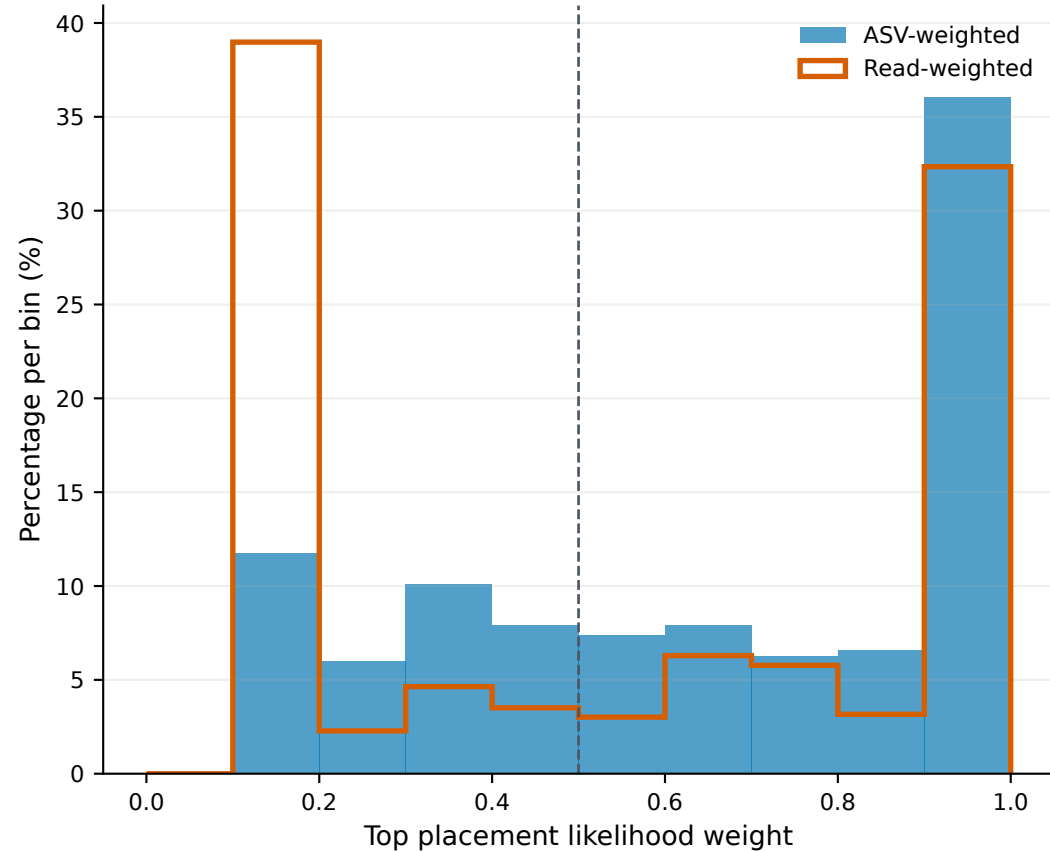
Support is concentrated for only some ASVs

Long pendant branches need separate review
